P5027A-03B-S

P5027A Keysight Streamline USB Vector Network Analyzer

Safety Service Note

"POTENTIAL BURN INJURY (HIGH TEMPERATURE) HAZARD" WARNING HAZARD CLASS 2

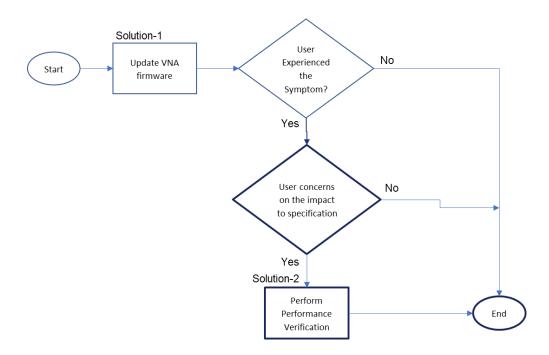
VNA fails to start with the following symptoms.

- 1. LED indicator (below circle) turns red.
- 2. cooling fan does not work

3. If user leaves the VNA with this LED indicator red without turning off power switch, it continues to overheat and becomes too hot.

Solution: Solution-1: Update VNA firmware by user

- 1. Install the latest VNA firmware **Rev. A.15.40.13 or newer** on users' controller PC(s). The latest firmware enhanced the thermal fan control mechanism.
- 2. Once the latest firmware is installed, proceed with the restart of both **controller PC** and **VNA**.
- 3. Launch the VNA firmware. Ensure VNA powers up and launches into firmware correctly after firmware update is done.
